APPIN MINE AREAS 7 AND 9 LONGWALLS 709 TO 711 AND 905 EXTRACTION PLAN MAIN DOCUMENT

Revision	Description of Changes	Date
ICH Document		
1.0	Original Document	July 2021
1.1	Updated to address feedback on draft EP application	October 2021
1.2	Updated to address IAPUM advice on EP application	July 2022

Figure 4 Investigated sites NAV2, NAV3 and F02.

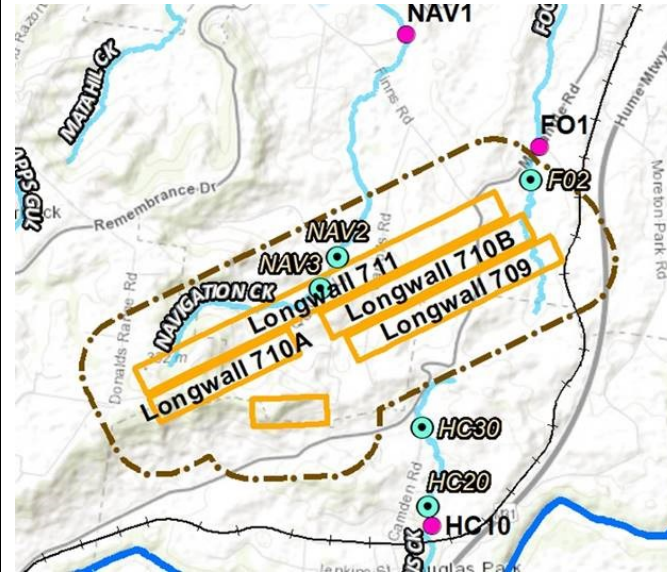
COMMENT	RESPONSE
Biodiversity and Conservation Division (<i>Letter dated 6 August 2021</i>)	
<p>Attachment 1</p> <p>Longwalls 709 to 711 and 905 will directly undermine 3rd order sections of Navigation Creek, Navigation Creek Tributary 1 and Foot Onslow Creek. Geomorphically, these creeks appear to be a chain of ponds system, with a significant number of farm dams in both the Navigation and Foot Onslow Creek catchments. Where there are permanent (or near permanent pools) on these drainage lines, they are poorly studied.</p>	<p>Navigation Creek is ephemeral and only flows during periods of extended, moderate or high rainfall. The headwaters of Navigation Creek are located within the Longwalls 709 to 711 and 905 Study Area with first and second order streams within the steep ridgeline of remnant bushland to the northwest of Appin Mine. The majority of the remaining catchment, including that of the third order stream, is comprised of agricultural land. Navigation Creek is predominantly highly disturbed and in poor condition. Stream banks are often steep with vegetation often consisting of weeds, and areas of minimal vegetation with evidence of erosion and scouring. Some pools have naturally established along the reaches; however the majority of the upper reaches consist of depressions and minor drainage lines intersected by a number of farm dams with little to no signs of flow. Any surface water flows from the upper reaches are predominantly captured within these established farm dams with runoff likely to only contribute to the downstream Nepean River during periods of extended or significant flow. Hence, the influence of this watercourse on flow and water quality within the Nepean River is minimal (SLR 2021b).</p> <p>Foot Onslow Creek is ephemeral and likely only flows during periods of extended, moderate or high rainfall. Foot Onslow Creek exists as a third order creek within the Study Area, with some minor first and second order streams. Within the Study Area the watercourse resides chiefly within agricultural land. Foot Onslow Creek is predominantly highly disturbed and in poor condition. Stream banks show areas of significant scouring and erosion with steep to near vertical walls. On shallower banks vegetation consist primarily of grassland and weeds. Stream bed material consists of loose sediment with grass and reed growth in some locations. Surface water flows from the upper reaches are predominantly captured within a number of established farm dams with runoff likely to contribute to the Nepean River during periods of extended or significant flow only. Hence, the influence of this watercourse on flow and water quality within the Nepean River is minimal (SLR 2021b).</p> <p>The sections of Navigation Creek and Foot Onslow Creek above the longwall goaf within the Study Area are located on private property, limiting the accessibility to these areas. However, monitoring sites above the longwall on sections of Navigation Creek and Foot Onslow Creek available on public property were investigated during the development of the Extraction Plan application. For example, Sites NAV2 and NAV3 shown in the image below were visited and no</p>

suitable sites were located near the longwalls, particularly for pool water level monitoring. At F02 on Foot Onslow Creek, pools were identified. IMC has a long term monitoring site at F01 which measures the presence or absence of water in the pools. No site is proposed to be established at F02. F01 is located downstream of mining and is considered suitable for monitoring on this watercourse.
